# Kirklees Council

## Proof of Evidence of Adam Darwin FIHE

**Appeal reference:** APP/Z4718/W/25/3375000

**Site:** Land north east of, Shepley Road, Stocksmoor, Huddersfield, HD4 6XW

**Figure 1 – Location of (unrecorded) footpath entrances at Ch.540 & Ch.790 on Stone Wood Lane**

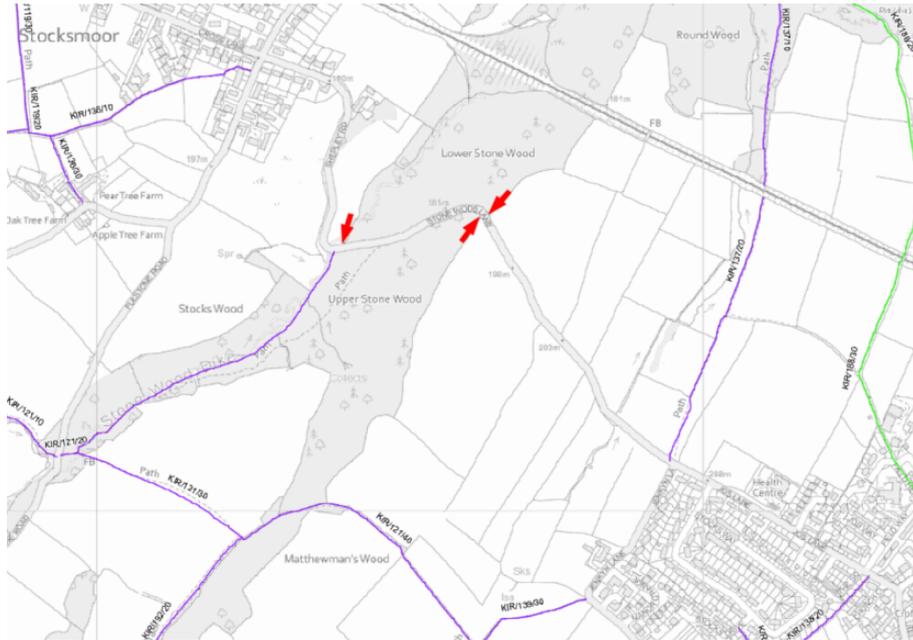
also includes a further access to the woods at and Ch. 790), which lead into Lower Stone Wood and Upper Stone Wood to the north and south of Stone Wood Lane respectively, which provide onward connections to the wider footpath network. Whilst these paths are not recorded on the Council's Definitive Map and Statement, they are well established and well used footpaths (based on my on-site observations), which have not been mentioned in the H&S SoC document or picked up in the survey data. Therefore, this omission also affects the reliability of the new survey data, and may explain why the active travel user flows at either end of Shepley Road & Stone Wood Lane do not match for the weekday survey (they can't match for the weekend survey as they were undertaken on different days), with some users taking circular walks through the wood that may not be picked up in the data.

- All of the surveys were undertaken in Autumn, when active travel users are unlikely to be at their peak (e.g. this would be more likely in summer months). Similarly, for the redone Saturday survey, this was undertaken during wet conditions, and it is clear from the data that this has suppressed the active travel user flow data. This is clear as the data undertaken at the Shepley Road end of the route, which the survey data sheets suggests was undertaken in dry conditions for both survey days, shows that the active travel users at the weekend (52 users over the 12hr survey) were substantially higher than the weekday data (31 users over the 12hr survey). However, for the data obtained on Stone Wood Lane to the southeast, which includes the redone weekend data obtained in wet conditions, this shows the complete opposite, with substantially fewer active travel users (8 users over the 12hr survey) for the weekend survey than for the weekday data (24 users of the 12hr survey). Therefore, the weekend survey data undertaken in wet conditions is not useful for assessment purposes.

Figure 7.1 Illustrates what various carriageway widths can accommodate. They are not necessarily recommendations.

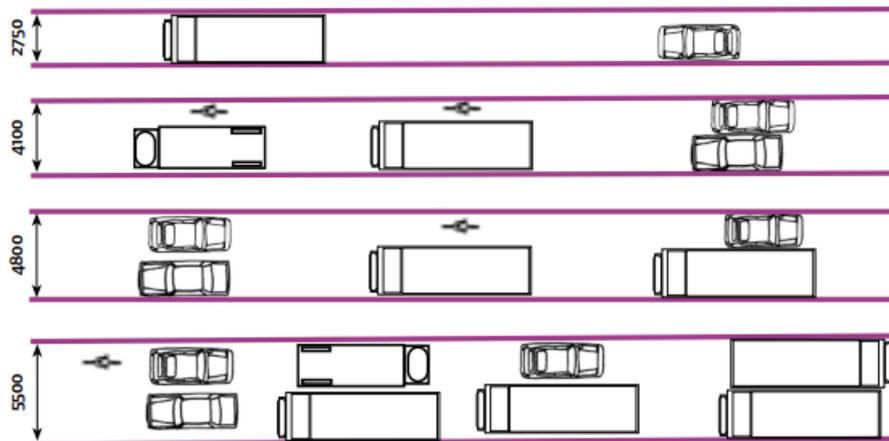
- 4.45 The Appellant has suggested that a 4.8m carriageway width is adequate to allow a car to pass a van, and a 4.1m width is sufficient for two cars to pass. They have based this assumption on the dimensions shown on Figure 7.1 of MfS1[CD 7.3], which is extracted below:

- 4.46 I accept that a 4.8m wide carriageway can allow a car and van to pass at low speed (e.g. less than 20mph), but the level of clearances I have previously identified would be significantly reduced (e.g. based on a 2.4m wide van, passing a 2m wide car, the available width between the passing vehicles and each edge of carriageway would be approximately 0.15m if split evenly). Therefore, this narrower width would involve closer passing of vehicles, increasing the risk of collisions between passing traffic (e.g. clashing wing mirrors etc.). This also doesn't take account of the edge treatment at the side road, which requires additional clearances (e.g. a safe distance would be 0.5m to a boundary wall, fence or other vertical obstruction, as previously mentioned).

- 4.47 However, I do not accept that a 4.1m carriageway width is adequate to allow two cars to safely pass, as this would only provide 33mm clearance (if evenly split 3 ways) between vehicles and each edge of carriageway, which is clearly inadequate at any speed. It is also noted that Figure 7.1 from MfS [CD 7.3] states that the identified widths are not recommendations. Whilst I acknowledge that smaller cars may be able to physically pass at this narrow 4.1m carriageway width (and this does occur on Stone Wood Lane at the very narrowest of the passing places that exist), this is not a safe or comfortable width for vehicles to pass, and is likely to result in low speed collisions with passing traffic or adjacent boundary features (an issue I have experienced myself when using the route, where I have scraped my vehicle on vegetation when passing at one of the very narrow informal passing places / PP-F).

**Figure 2 – Middle Super Output Area (MSOA) 051 & 056**

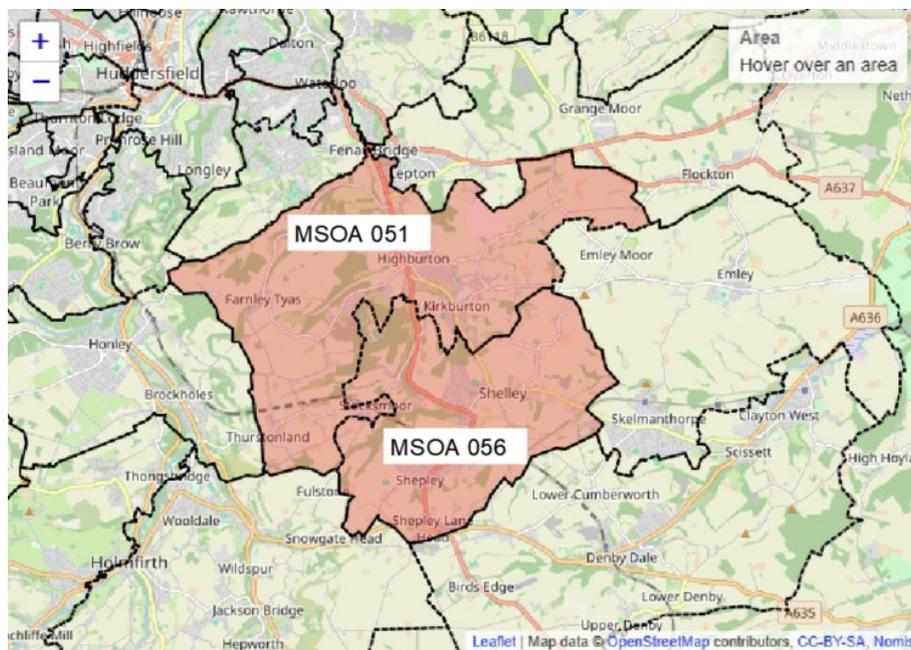
- 5.34 Data from TEMPro for Middle Super Output Areas (MSOA) 051 & 056 (See MSOAs on Figure 2 below) has been used to determine vehicle journey purpose for car trips (rather than assessing all mode trip types, which is a better approach) at the Appeal site. This data has been used as Stocksmoor lies on the edge of these two MSOA, which the LPA does not dispute. However, using this data from a wide area, and then applying it to the Appeal site is incorrect, as this assumes that the travel patterns and modal split of people living in Stocksmoor are the same as people living in the remaining areas of MSOA 051 & 056. It is noted this wider area includes the villages of Shepley, Shelley, Kirkburton and Highburton, which all have a range of local facilities, including schools (both primary and secondary), shops, medical facilities etc. that are within easy walking distance. This is not the case for the Appeal site, which is not within easy walking distance of any such facilities, and the most direct walking route to the nearest facilities that accommodate the daily needs of residents is along Stone Wood Lane when walking to Shepley (a walk of over 1km before reaching any local facility). In particular, the data relating to primary education trips will certainly not be the same for the Appeal site as in the wider MSOAs, as it will be easy to walk to a primary schools for a large proportion of people living in the other villages, which will clearly not be the same for the Appeal site, where it is likely that the vast majority of all trips to/from primary school will be by car (or by bike, should parents feel safe to do so). Unfortunately, the TEMPro database cannot be focused in sufficiently to consider only Stocksmoor and surrounding rural areas that are less accessible, to allow more localised journey purpose information to be considered. Had this been the case, using the smaller Lower Super Output Area scale census data (e.g. If it

- 5.35 The Appellants H&T SoC document [CD 8.2] has assigned commuter trips using 2011 Census data for MSOA 051 & 056. Whilst it has not been confirmed in the report, it is understood that this has been done using the *'WU03EW - Location of usual residence and place of work by method of travel to work (MSOA level)'* dataset, utilising the car/van driver data. This assessment approach is relatively standard and has been used for many years, and can provide an indication of commuter traffic distribution (and is often used as a proxy for the modal split for all journey types). However, the 2011 Census data is now old and does not reflect current commuter patterns. Unfortunately, the later 2021 Census data cannot readily be used for the same purpose, as it was affected by Covid restrictions, so there is no more recent Census data that could be used. Therefore, the usefulness of the 2011 Census data is diminishing, as the data is outdated and unreliable. This is one of the reasons why the LPA had asked for a 'first principles' type assessment of trips by all modes and trips types for the assessment, and accords with the principles in the NPPF that require a Vision-led approach to assessment and not 'predict and provide' as has been done consistently by the Appellant's various transport consultants in their assessments.

**Figure 3 – Lower Super Output Area (LSOA) 051D**

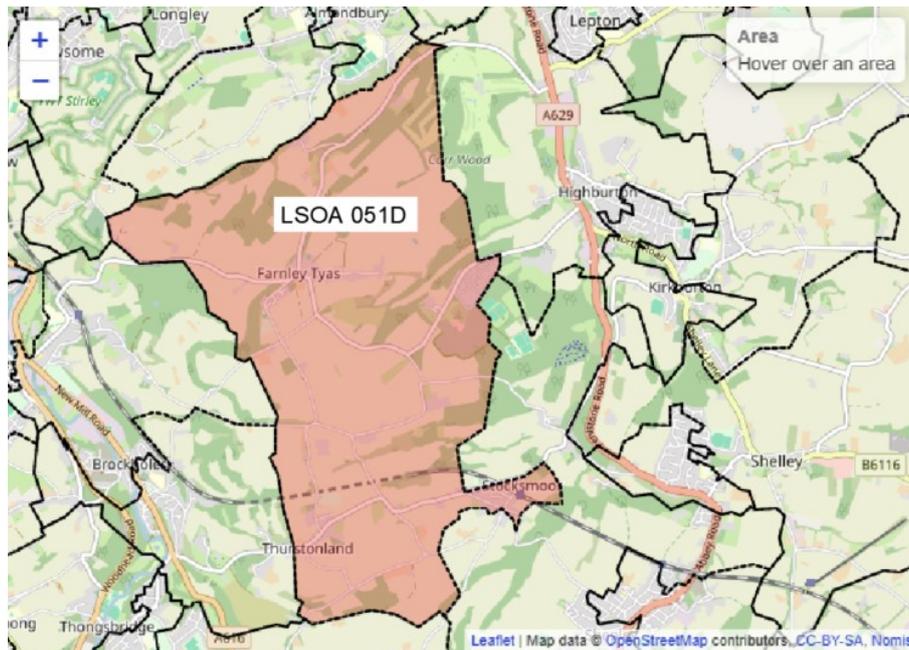
had been possible to use LSOA 051B – see area on Figure 3 below), could have provided more representative data for trip distribution purposes (and using the data for all trip types). However, TEMPro can only consider the larger MSOA datasets, which in this case incorporate villages with very different travel characteristics to Stocksmoor. As such, the journey purpose data for car trips used by the Appellant are unreliable, and provide a flawed assessment approach, ignoring that during peak hour periods, more people will be travelling by car for other purposes (e.g. taking children to primary school) who live in Stocksmoor. A better approach would have been to determine journey purpose for all trip types during network peak periods, and then applying a reasoned and justifiable modal split to each trip type (e.g. 100% of primary school trips by car).
